# MAZDA AUSTRALIA PTY. LIMITED

## - Mazda CX-60 (KH), CX-90 (KK)

Recall number	REC-005882
Campaign number	R202401
Original published	30 January 2024

# Part 573 Safety Recall Report

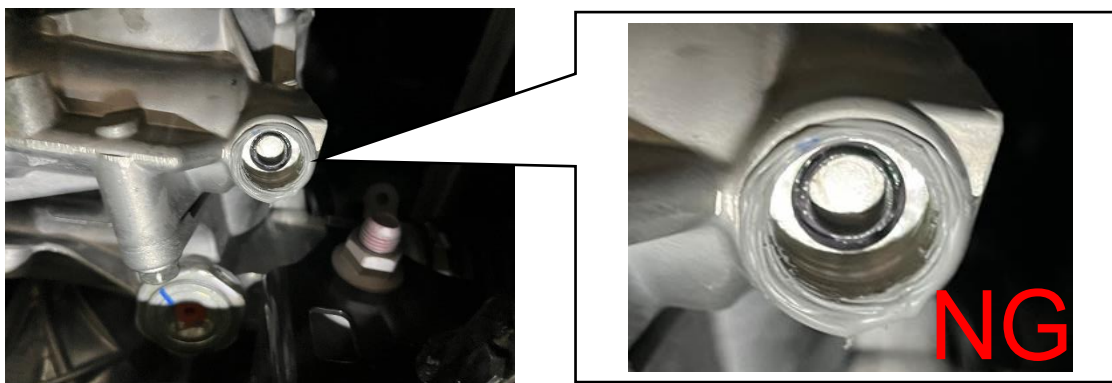
How Remedy Component Differs from Recalled Component : The remedy component reduces the spring force to the worm gear in the steering assembly.

16. Take out the cap, spring, end cap, and grease from the replacement parts kit and replace into the hole. Apply the grease to both ends of the spring and the tip of the cap. Grease is applied to prevent parts from falling during installation. NOTE: Wire Diameter is smaller.

Old Spring Color: Half White Coil	New Spring Color: Black All Coils
